DrawDiff Comparison Report

Part number: P-001 | Job: 3ee0b4d0-0792-4947-ac7b-f32e4a108eb6 | Generated: 2026-04-30T02:49:38+00:00

SECTION B-B [ADDED]

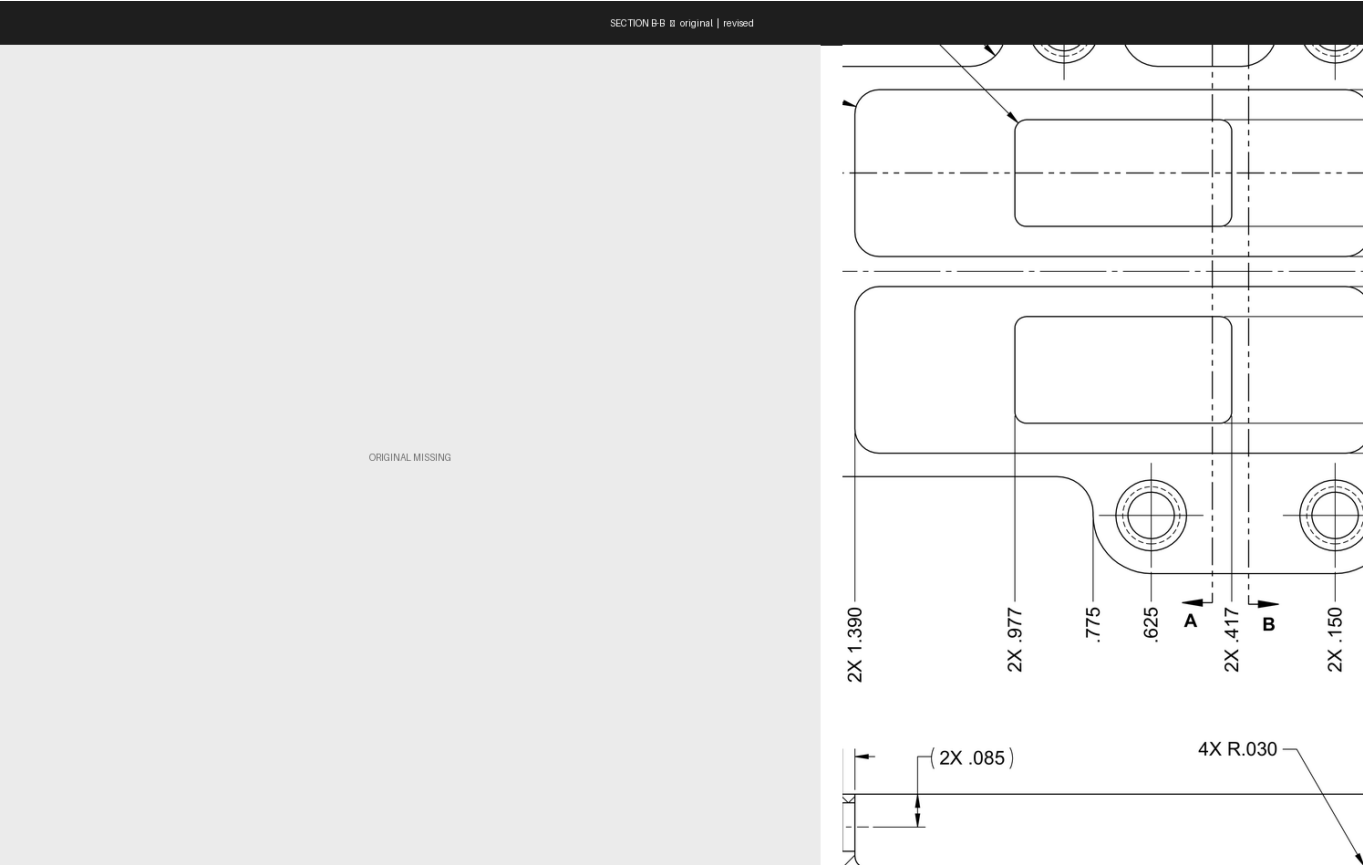
Severity	Field	Original	Revised	Conf.	Rationale
SIGNIFICANT	view	—	SECTION B-B	1.00	View 'SECTION B-B' appears only in the revised drawing.
